## **Architectural Review Board Staff Report**

**Project Type:** Amended Site Development Plan (3<sup>rd</sup>)

**Description:** **Chesterfield Outlets (17107 N Outer 40 Road – The District)**: An Amended Site Development Plan, Landscape Plan, Lighting Plan, Architectural Elevations and Architect's Statement of Design for a 48.2 acre tract of land located north of N Outer 40 Road and east of Boone's Crossing. (17T420027)

Staff requests review and recommendation on this submittal for Chesterfield Outlets (17107 N Outer 40 Road – The District)

Figure 4: Existing vs Proposed Height and Length

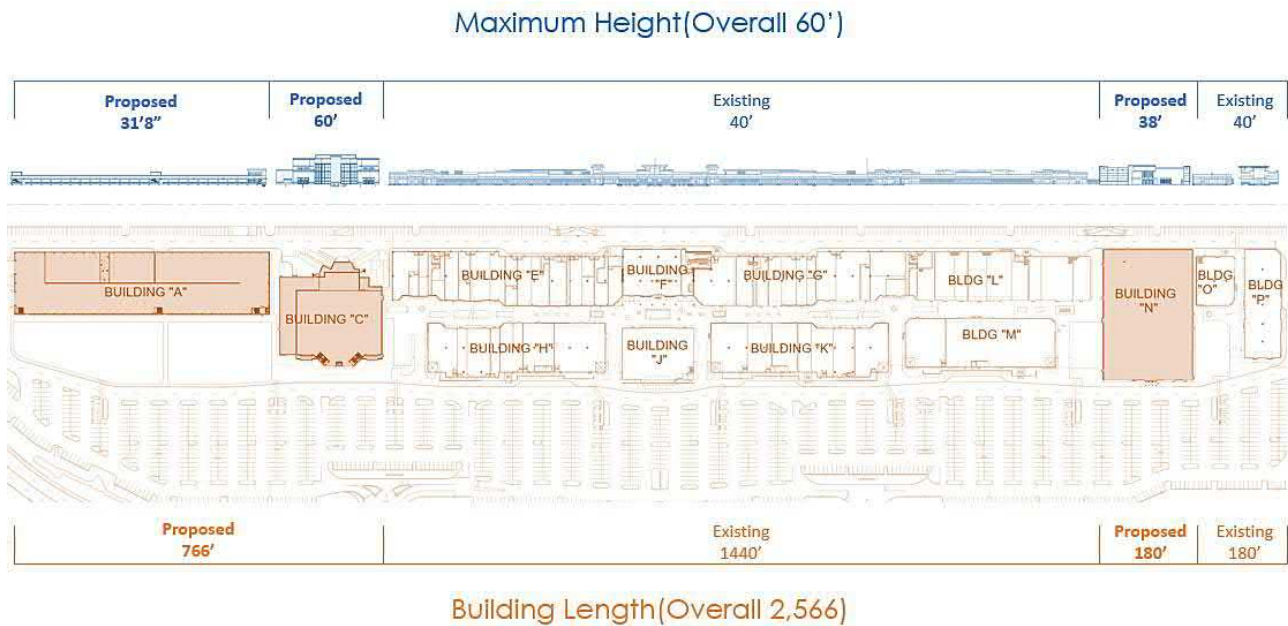
Given this development will ultimately be achieved in phases, new buildings will be situated adjacent to the existing buildings and this review is for the development incorporating these changes. There are no planned changes to the existing buildings to remain. The existing buildings have a base height of 20’ with accents ranging from 24-28’ in height. Feature elements at the corners reach a maximum height of 40’. The new buildings will range in maximum height from 38’ (Recreational Facility) to 60’ (Music Venue). The height differential between existing and proposed buildings is depicted in blue in Figure 4 below. The appearance will also change visually from east to west. Approximately 946’ of the total 2,566 linear feet of virtually contiguous buildings, or 37% of the visual frontage, will be new in appearance, as seen in orange also in Figure 4.

Figure 9: Music Venue Lighting

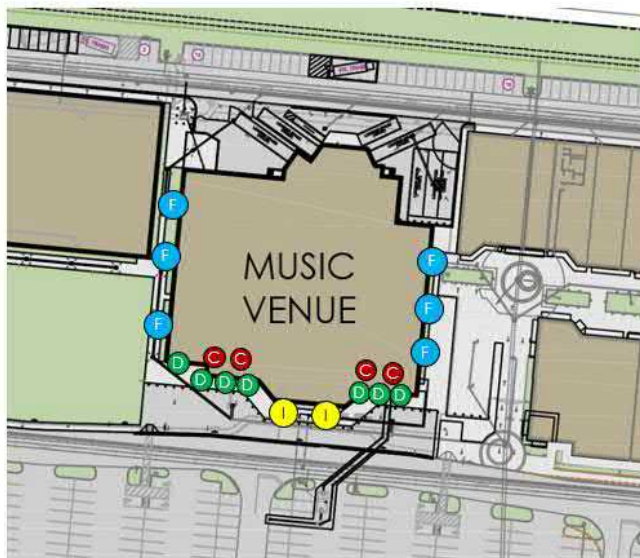
Figure 9 below depicts the decorative lighting for the Music Venue. This lighting will include two features that are directed upward. One is a flood light approximately 1 foot above grade and one is

an ingrade uplight. The Unified Development Code specifically states to avoid floodlighting for facades of buildings facing I-64. The applicant has also stated that no uplighting will trespass beyond the roofline of any structure. Other decorative fixtures include a canopy downlight and wall sconces solely on the south façade.
